addendum

subject: Addendum No. 03
Steward Street Park
Hanahan, SC
COH Project No. 060523 | ADC Project No. 20381

subject: Addendum No. 03 – Response to Bidder’s Questions

EXISTING SITE & DEMOLITION PLAN

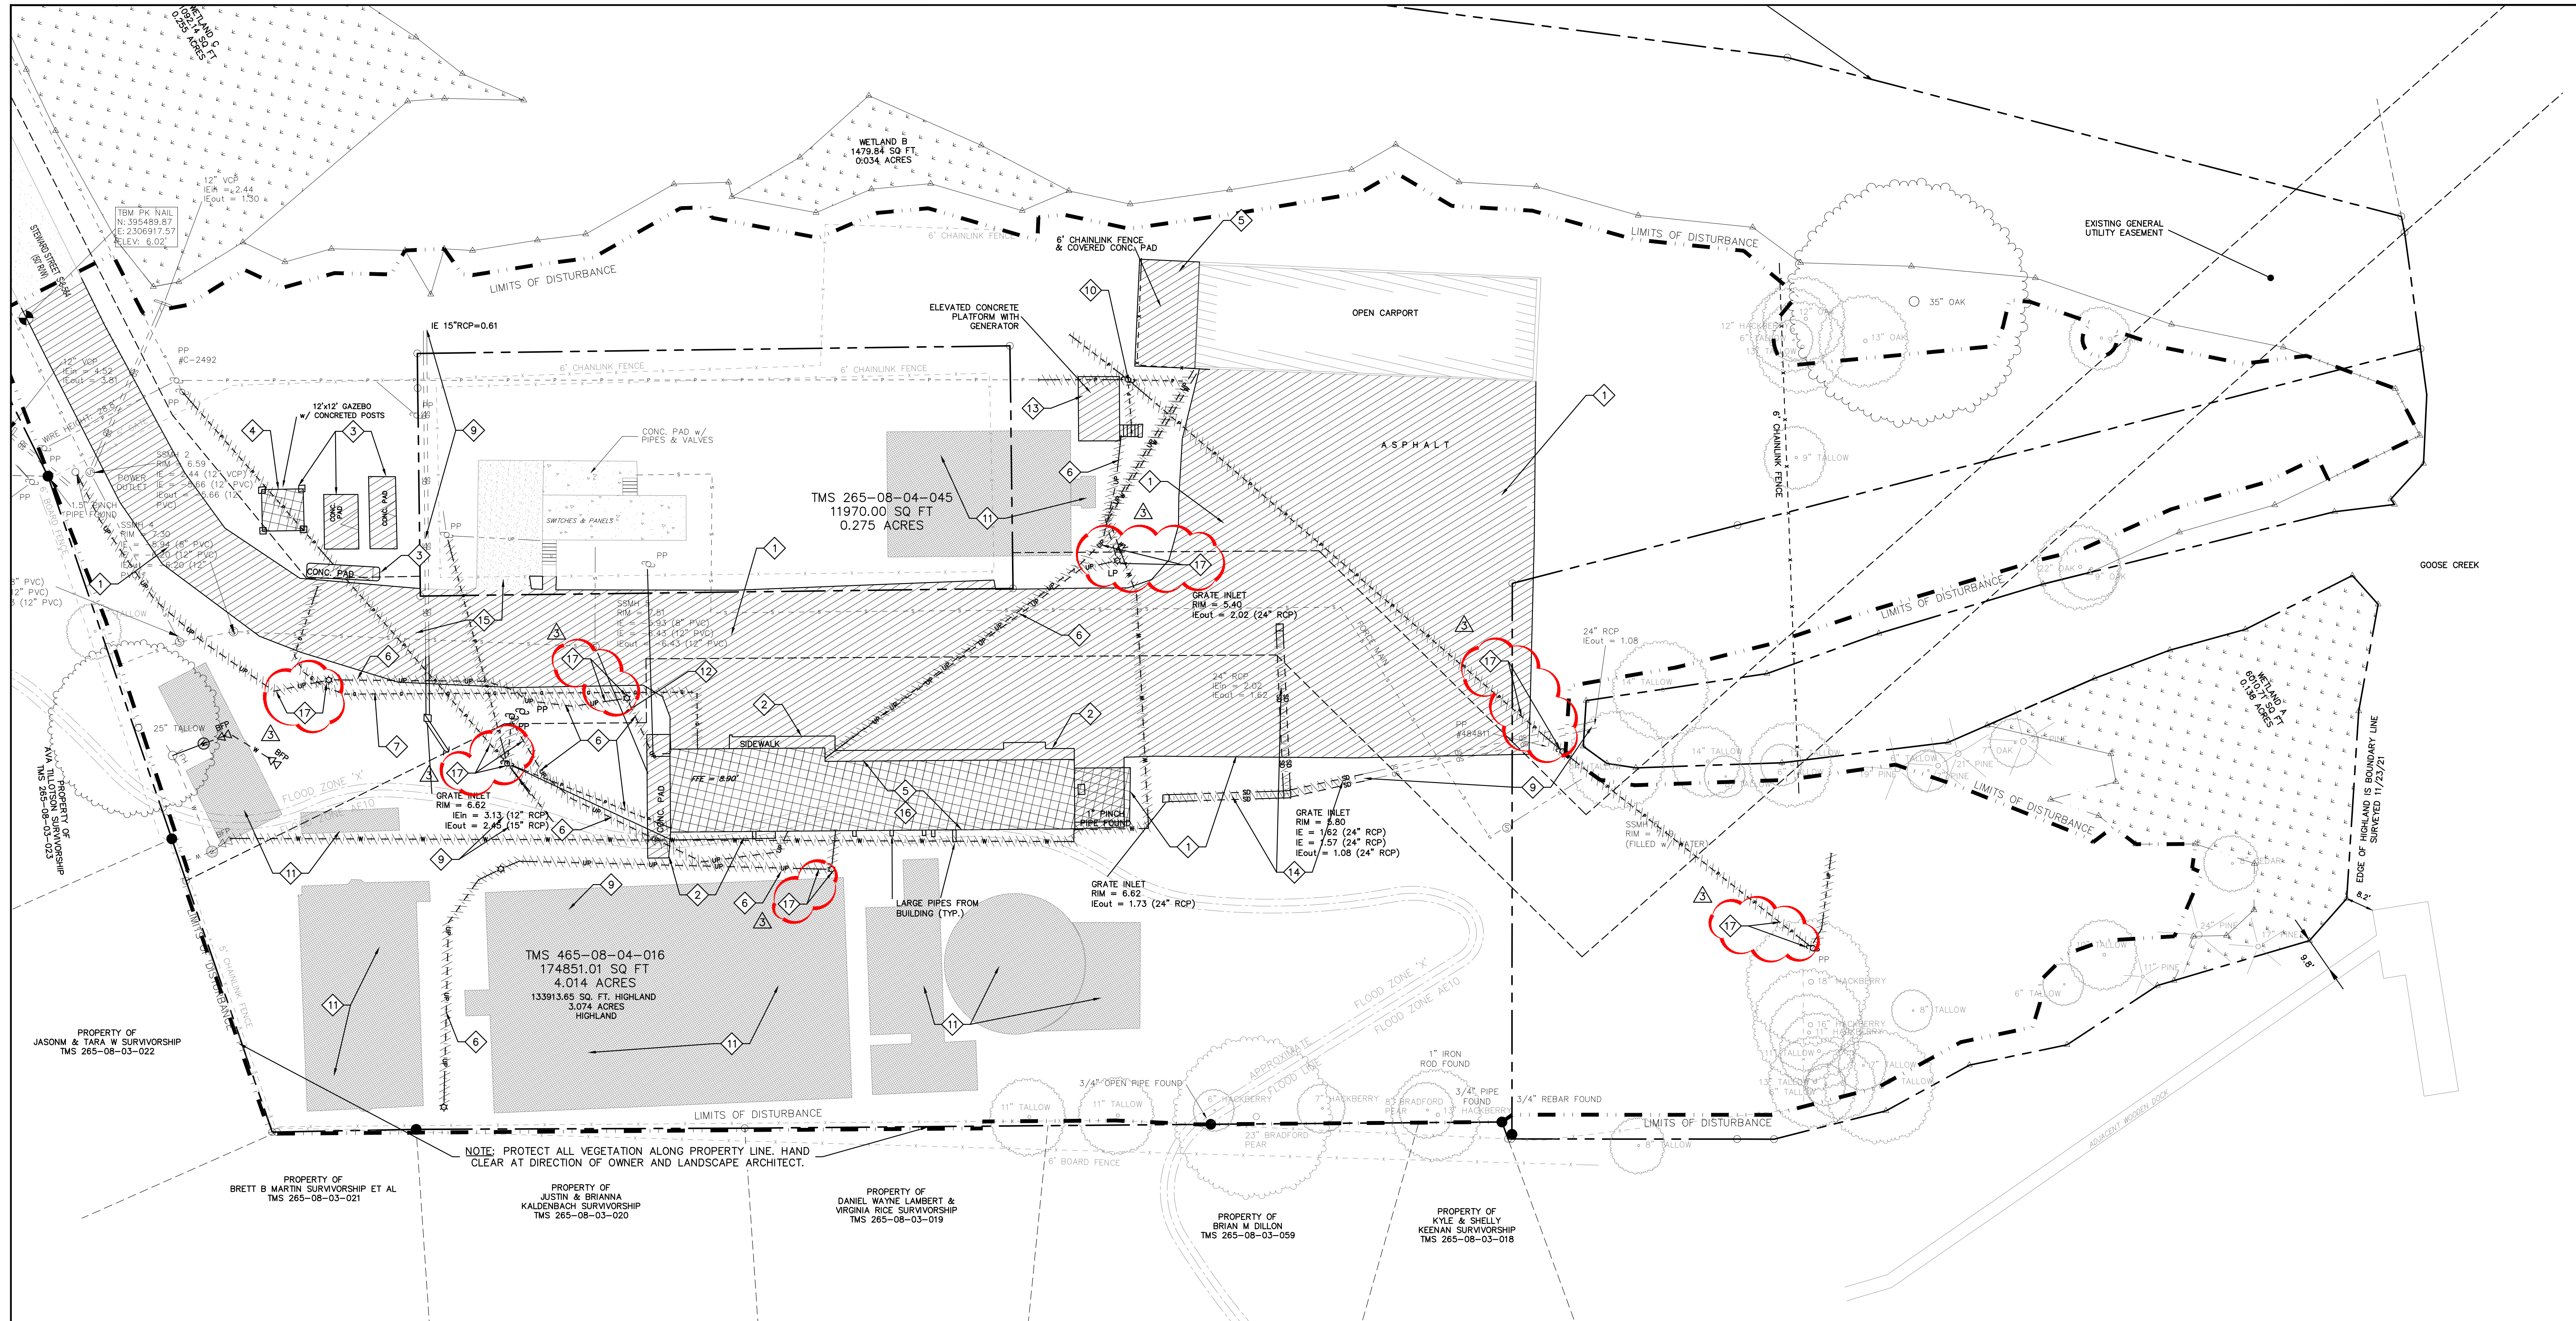
1. SHEET C001 – CIVIL LEGEND, ABBREVIATION & NOTES: Replace Sheet in its entirety. The Sheet is being replaced to modify the List of Drawings to show revision to Sheet C110.
2. SHEET C110 – EXISTING SITE & DEMOLITION PLAN: Replace Sheet in its entirety. The Sheet is being replaced to clarify work associated with power poles and light poles.

Question #	Question	Response
1.	<p>In response to the answer provided for Question 8 in Addendum 2, regarding the request to specify an allowance for work associated with Note 16 on C110, we request the Owner reconsider its position and provide an allowance for the scopes of work associated with Notes 5, 11 and 16 on Sheet C110.</p> <p>In order for the bidder to determine the extent of work required and associated costs, each bidder, prior to submission of its bid, would be required to mobilize equipment such as a backhoe or excavator to excavate areas identified. This would include, at a minimum, excavations to determine the length, width, and depth of each section of concrete foundation.</p> <p>Knowing that some of the foundations are from a sewage treatment plant, the concrete depth could be considerable as well as potentially being pile supported with pile caps and grade beams.</p> <p>It is not practical to expect all Bidders to mobilize this equipment nor perform this type of investigation prior to its bid submission. Furthermore, it is doubtful the Owner desires this type investigation being performed multiple times by different contractors. It would seem the most practical means to address this condition would be to specify an allowance amount.</p>	<p>The treatment building foundation is noted to be removed in its entirety (Keynotes 5 and 16). All other foundations have been removed to a depth of 18” below grade (Keynote 11). Additional removal of those foundations is only required if conflicts encountered with new work.</p>

3.	<p>Do all exterior foundations need to be demoed entirely?</p>	<p>The treatment building foundation is noted to be removed in its entirety (Keynotes 5 and 16). All other foundations have been removed to a depth of 18” below grade (Keynote 11). Additional removal of those foundations is only required if conflicts encountered with new work.</p>

Question #	Question	Response
5.	Does the power company remove all power poles, and light poles?	Refer to attached revised Sheet C110.
6.	Does the power company furnish, and install all new light poles, and hand holes?	Yes, the contractor is responsible for conduit.
7.	Does all existing plumbing in the pavilion slab get removed?	Only where the plumbing reaches the surface.
8.	Sheet E601 Lighting Schedule list type BR and type BG ballards. We are unable to locate these items on the drawings. Can we get clarifications on the location of these power poles? Or are these to be used in conjunction with note 3 and 4 on sheet E104? If so which is the correct guidance?	Type BR and BG bollards are no longer part of the project.

- REMOVE EXISTING POLE AND OVERHEAD WIRE AFTER TRANSFER OF POWER TO NEW POLES.
